**FLOODWAY DEVELOPMENT PERMIT #851-24-00640-PLNG  
BRUNS**

**ADMINISTRATIVE DECISION & STAFF REPORT**

**Decision Date: November 5, 2025**

**Decision: APPROVED WITH CONDITIONS**  
**(This is not Building or Placement Permit Approval)**

Figure 1 - Study area with effective FEMA flood hazard mapping

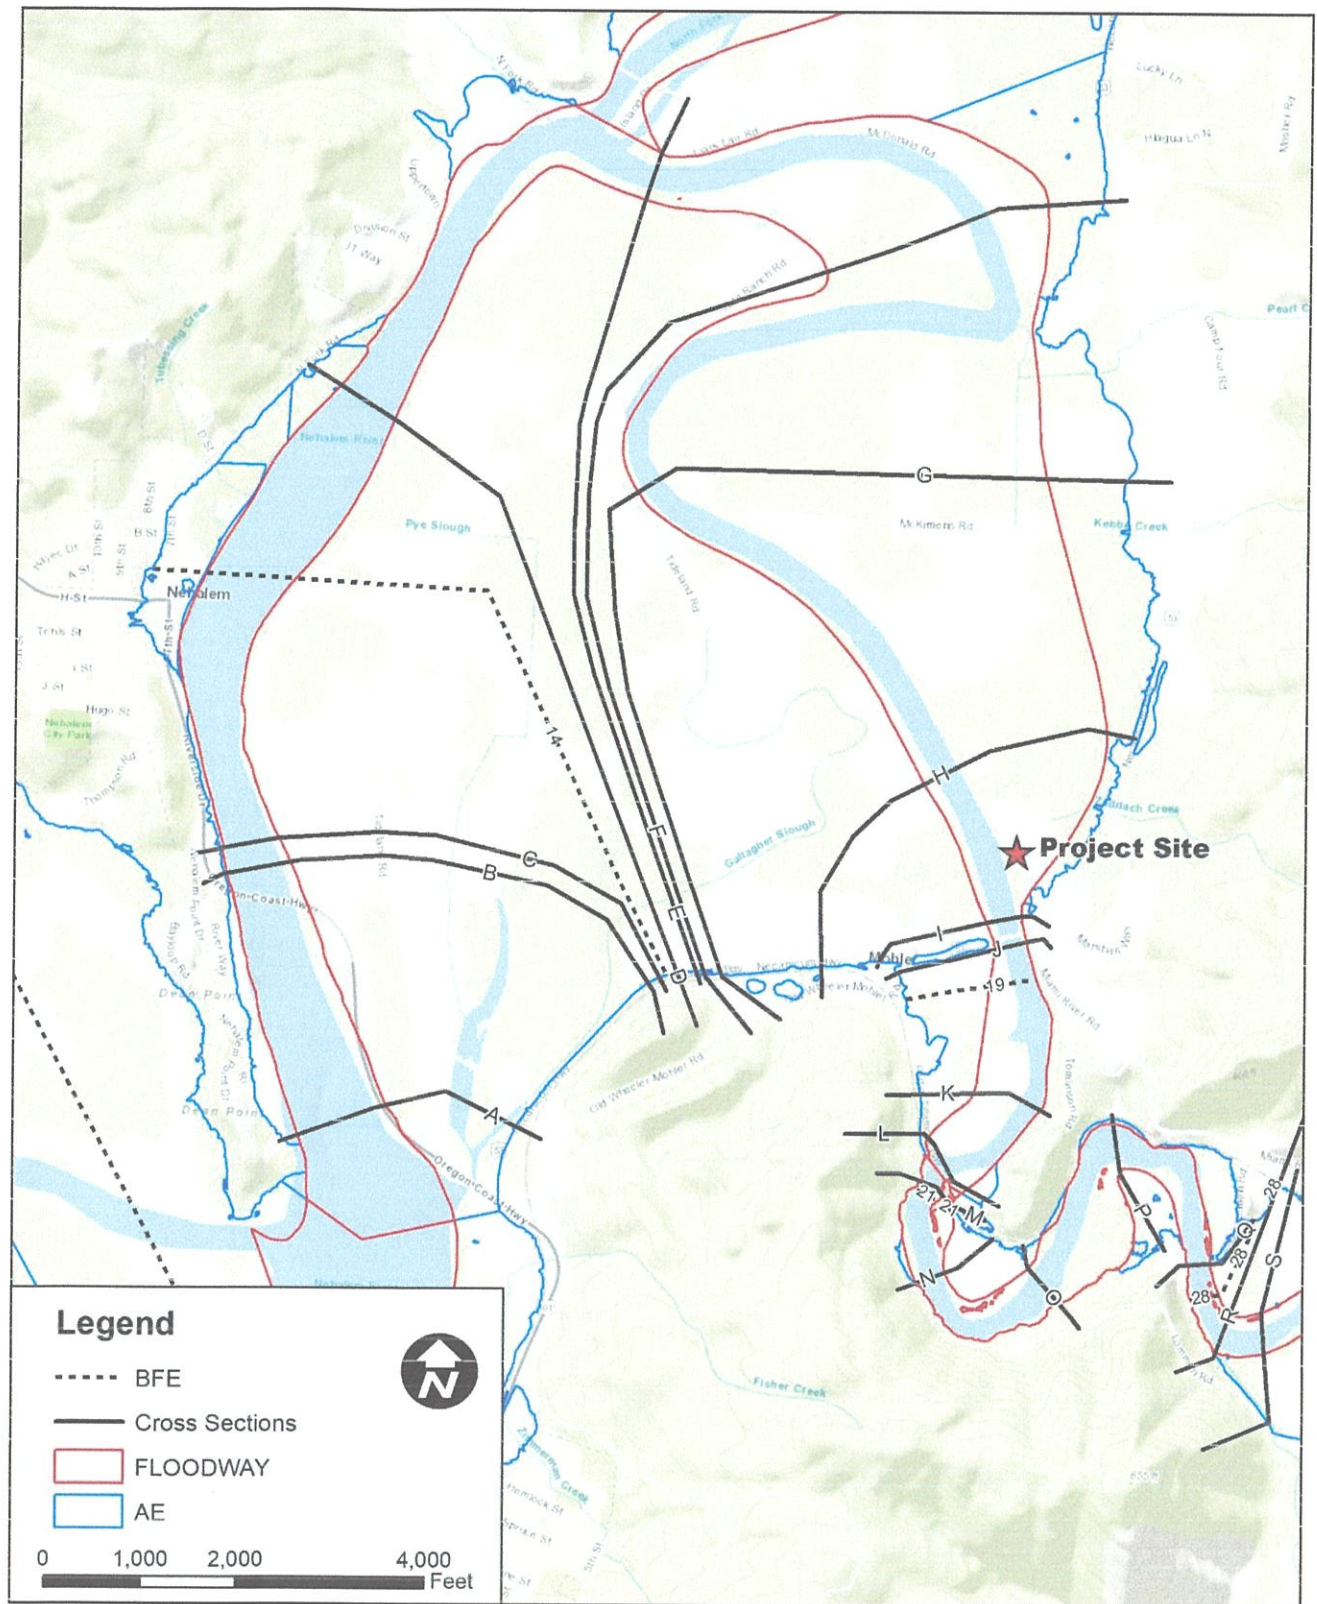
4. Note that the aerial photo in the no rise analysis does not show a shed or driveway on the property. Were these previously permitted by the county? Both features appear to be within the estuary setback. If this was an unpermitted activity, ODFW recommends the applicant work with the county to properly permit the construction, and that mitigation measures be applied to offset impacts to the riparian area. Consider requiring the shed to be removed or moved outside of the setback along with restoration of the riparian area.

Figure 5 – Site plan

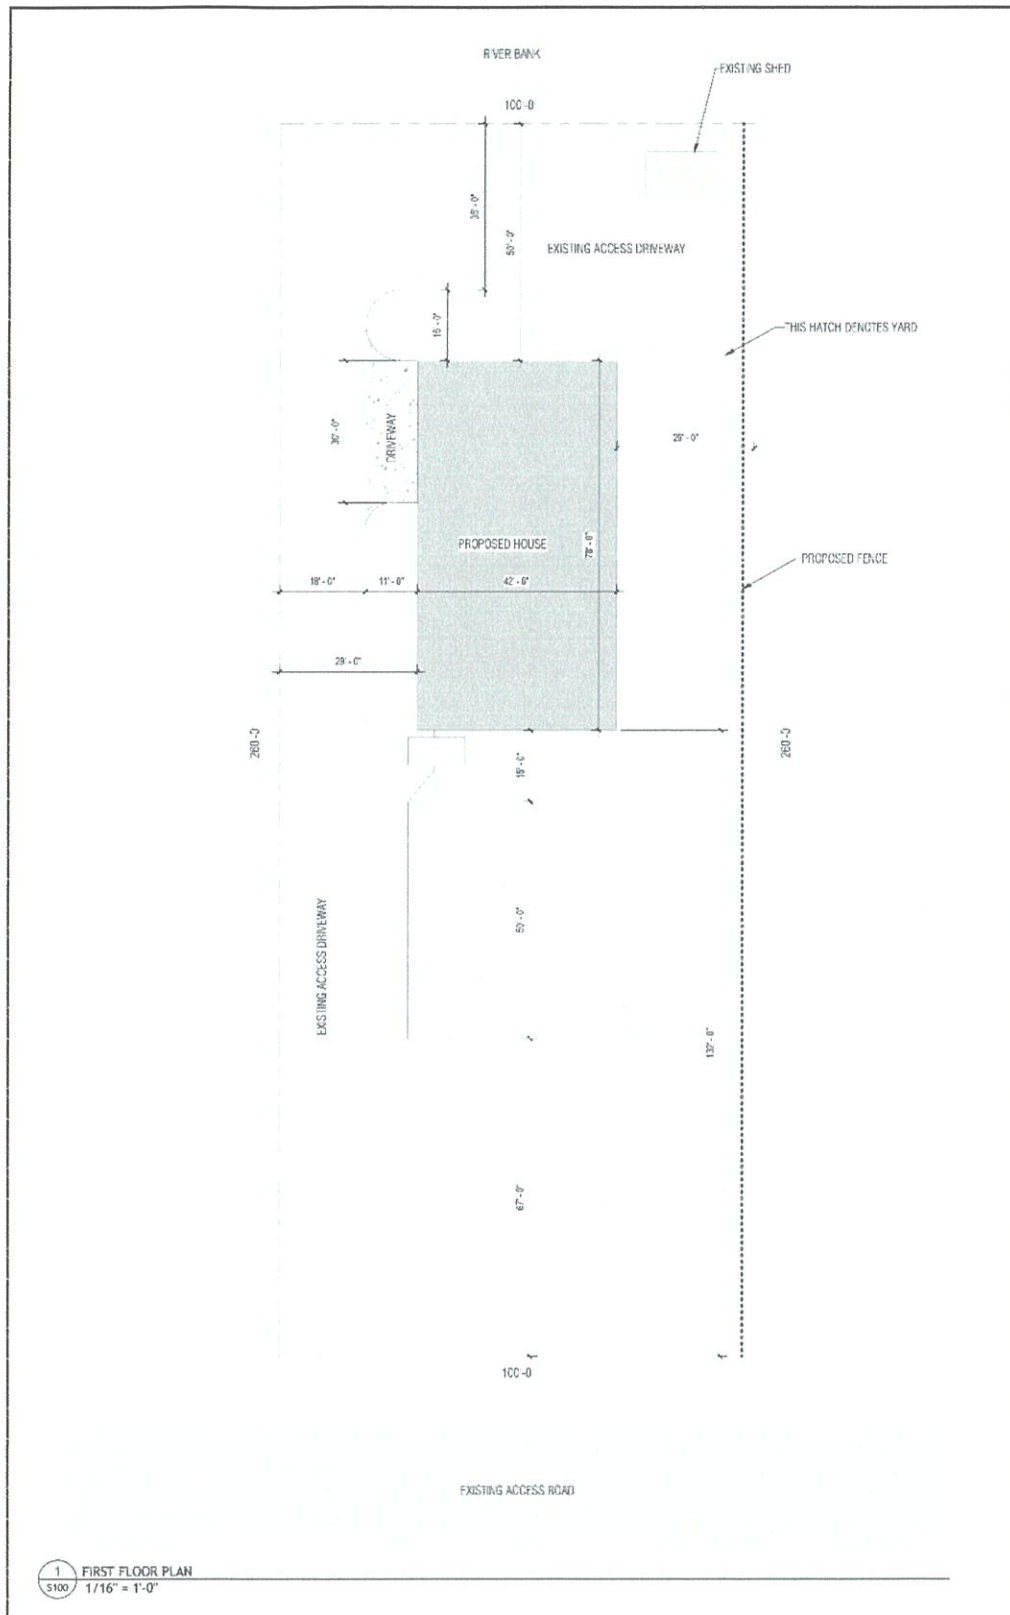
1. The attached drawings do not adequately show the location of the proposed house relative to the estuary setback. The drawing provided in the no rise analysis appears to show a 50 foot setback from the top of bank to the "proposed house" but does not specify if that includes the concrete pads, stairs, etc. as shown in the hand written drawing provided by the applicant. The hand drawing shows a 35 and 50 foot distance from something but does not specify. ODFW recommends all construction be located outside the estuary setback, including the concrete pads, parking area, and stairs.
